SERVICE BULLETIN

NEW RUBBER GASKET

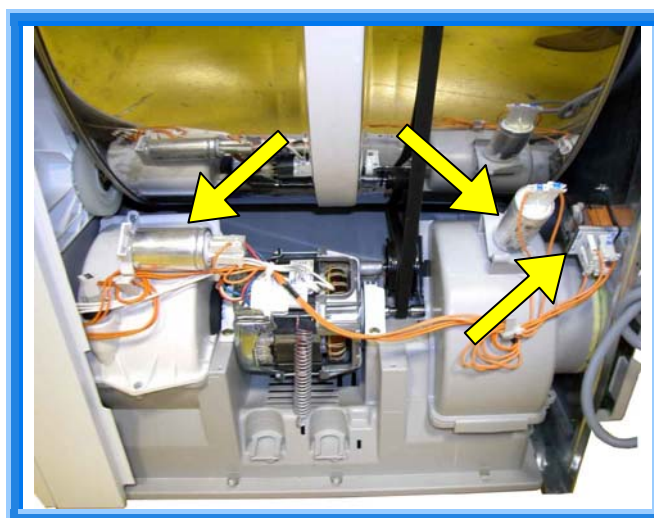
It has been discovered in the laboratories of the Siewierz factory (Poland) that in some dryers, after working hours in extreme conditions, on the motor shaft, which activates the front fan (hot air circulation) there was excessive humidity and cloth fibres came out from the front scroll. To avoid any possible malfunctioning a new basket has been introduced between the motor shaft and the front scroll cover.

Should similar problems arise on the above mentioned appliances without the gasket, it is advisable to remove the front scroll and to insert the gasket part no. **125 64 26 00-6** between the motor shaft and the scroll, as shown in figure and inform the Electrolux service department about the problem (error code 03).
